**Amendments to the Drawings:**

### REMARKS

FIGURE 2

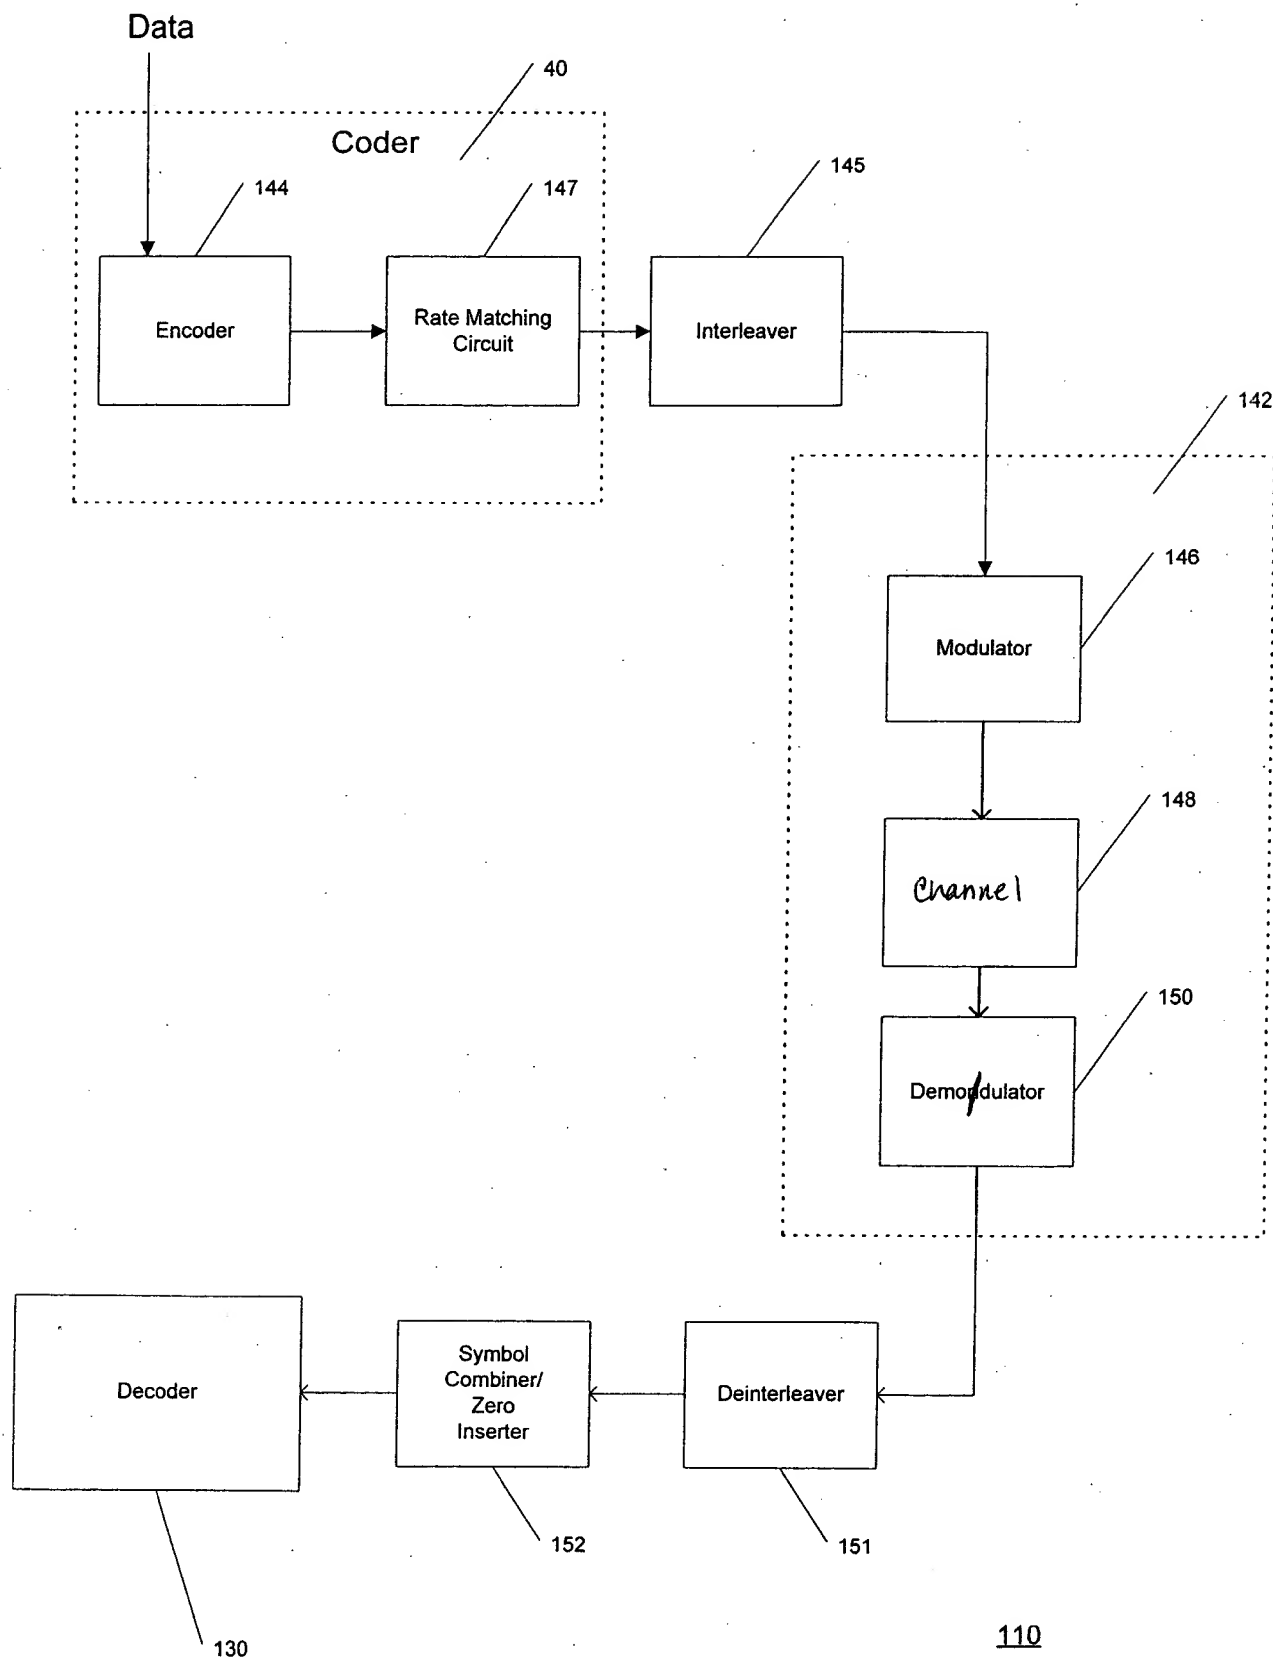
Drawing Figures 1-2 are amended herewith in accordance with the Examiner's requirements to label object 148 as "channel" and to add the legend "Prior Art" to Figure 1.

In response to the Examiner's drawing objections in section 2 of the current Office Action, Replacement Drawing Sheet 1 adds the legend --Prior Art-- to Figure 1, and Replacement Drawing Sheet 2 adds the legend --Channel-- to the block referenced 148. In addition, in block 150 the spelling of modulator has been corrected. The changes are indicated in red on the attached annotated copies.
